# FE-223 WD

## DESCRIPTIVE REPORT

State ..... Virginia.....  
General Locality .... Chesapeake Bay.....  
Locality ... Chesapeake Bay Entrance.....

SUBJECT: Quality Control Report for FE-223 (1975) WD, Virginia, East Coast,  
Chesapeake Bay Entrance

FE-223 WD  
A & D SHEET

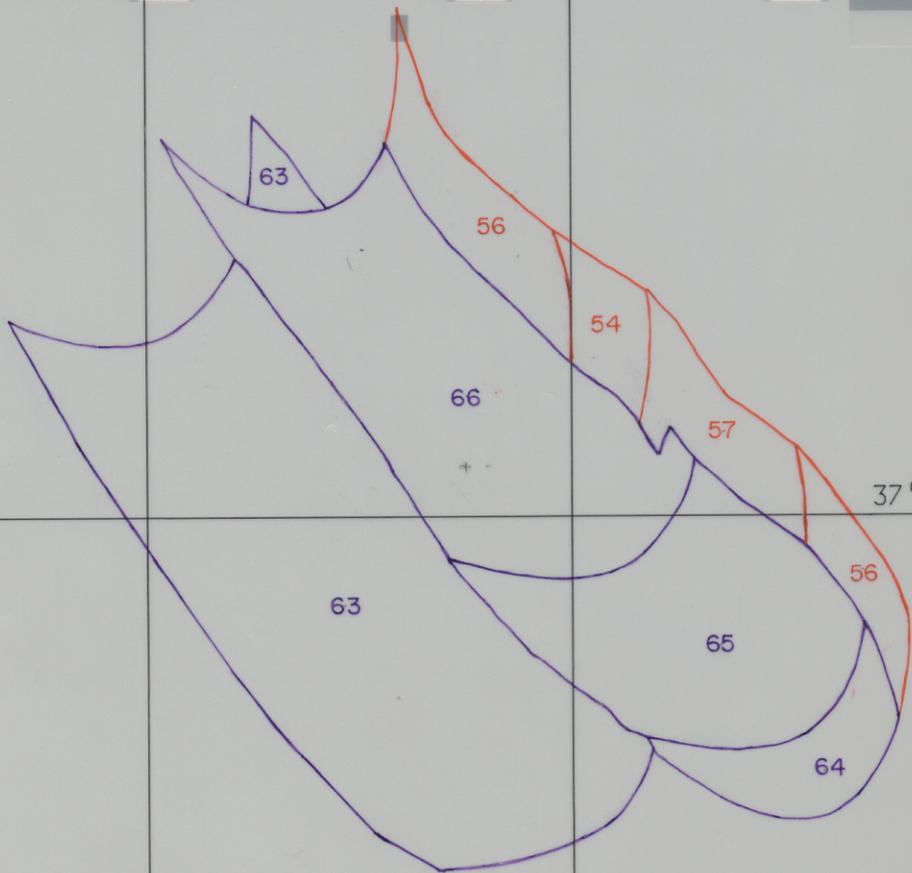
1. The verifier's discussion pertaining to the investigation of Item #2 was deficient in several respects as follows:

- The Verifier's Report should have included the charted geographic position of the wreck, latitude 37°00.1'N, longitude 75°34.5'W.
- A red ink notation by the verifier in the Descriptive Report, Section 0, Recommendations, concurs with the hydrographer's recommendation that the wreck be shown as nondangerous or removed from the chart. On the other hand, the Verifier's Report states that the item should be retained as charted. Recommendations or concurrences by the verifier should be explicit and consistent throughout the report.
- Two statements made by the verifier are conflicting. One states that the "item has neither been proven or disproved by this examination." The other states that "This wire drag field examination complies with the Project Instructions."

The maximum swept depths over the reported wreck (Item #2) are more than 3 feet from the bottom within a 1-mile radius of the reported position. Therefore, neither the project instructions nor the Wire Drag Manual requirements were satisfied in this instance.

Because the wreck has not been verified or disproved, the wreck symbol should be retained on the chart. Decisions on whether the wreck should be shown as dangerous or nondangerous, and whether a clearance note can be charted, are left to the Marine Chart Division in its development of standard procedures for portraying wire-drag survey results of this type. MCD, C-3212, Retain as charted. 8/21/81 JWC HPA

2. The statement in the Verifier's Report which considers the source of a charted "61" is probable. However, inasmuch as this depth could have originated with a miscellaneous source, it is referred to the compiler for further consideration.
